Draft amendment to ECE/TRANS/WP.29/GRRF/2010/29 (New Regulation on LDWS)

The text reproduced below was prepared by the expert of France to modify Annex 3 of ECE/TRANS/WP.29/GRRF/2010/29 with regard to road markings in France.

Table 1

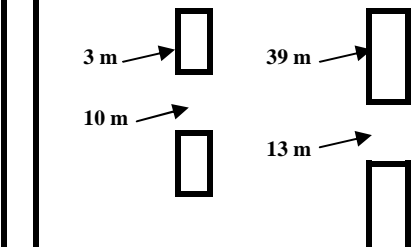
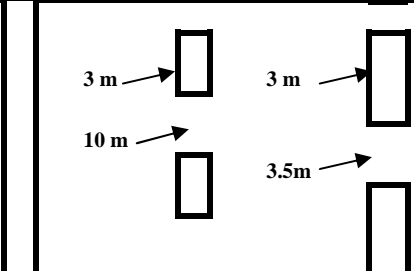
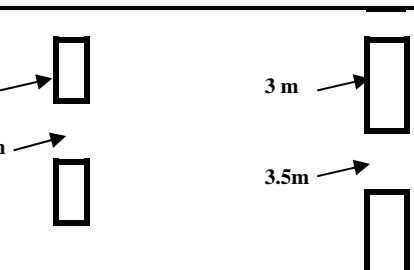
Annex 3, Table 1, replace line “France” by the following lines:

PATTERN			COUNTRY	WIDTH		
Left edge lane marking	Centre line	Right edge lane marking		Left edge lane marking	Centre line	Right edge lane marking
			Definition of lane width for the purpose of this Regulation			
			FRANCE Motorway (*)	22.5 cm	15 cm	22.5 cm
			FRANCE Highways (4 lanes or 2x2 lanes)	22.5 and 37.5 cm	15 cm	22.5 cm
			FRANCE (other roads)	10 or 12 cm		15 or 18 cm
